SERVICE BULLETIN

from: TRIO-KENWOOD COMMUNICATIONS, INC.

SUBJECT: TS-180S DFC

DATE 9/10/79

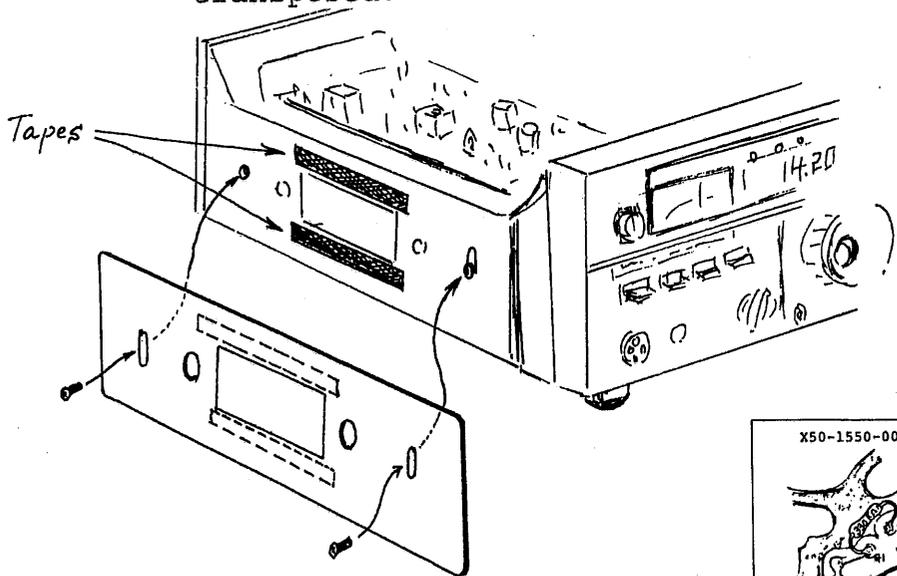
For complaints of either induced power supply hum, or intermittent frequency stability while using the DFC, perform the following changes to the VCO unit X50-1550-00:

- *1. Install a 330K ohm resistor between Q11 G1 & the 8V line. Connect from L7 at C12 to Q11 G1, at R35.
- *2. Replace L12 68uH with new part L40-6831-21.
- *3. Replace L13 150uH with new part L40-1541-27.
- *4. Install magnetic shield as illustrated. Use the two existing screws, plus double faced tape to prevent vibration.

Note: On page 37 of the Service Manual, the VCO Board view shows reversed callouts for Q11 & Q15. D & S, and G1 & G2 are transposed.
